Mask Set Errata

MSE908AS60_8H62A 12/2002

Mask Set Errata for 908AS60, Mask 8H62A

Page Program/Margin Read Procedure

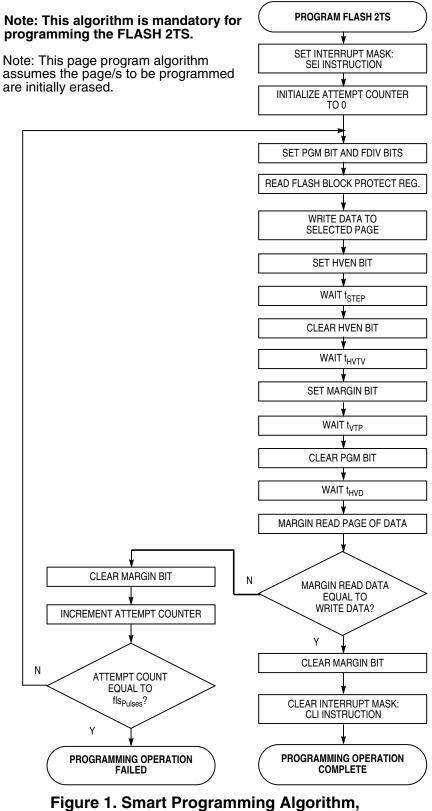
Cumulative program time exceeding 100 steps per page may cause unintentional programming of erased bits. This condition is known as program disturb.

| | Level | 25°C | 85°C | 105°C | 125°C |
|-----------------------------|------------------------------------------------------------------------------------------------------------------------------------------------------------------------------------------------------------------------------------------------------------------------------------------------------------------------------------------------------------------------------------------|--------------------|-------------------|------------------|-------------|
| FLASH Memory Programming | Use of the smart programming algorithm, the iterative page program/margin read technique, is required. | | | | |
| | When using the iterative page program/margin read technique, a maximum of 100 programming pulses is allowed. The minimum duration of the programming pulse (t_{STEP}) shall be 1 ms. The t_{STEP} duration is defined as the amount of time during one program cycle that HVEN is asserted (HVEN = 1). The maximum t_{STEP} is 1.2 ms. Therefore, the maximum cumulative program | | | | |

At 25°C and above, with the minimum page program step (t_{STEP}) of 1 ms, the maximum page program time is 100 ms.

time (t_{PROG}) per page is 120 ms.
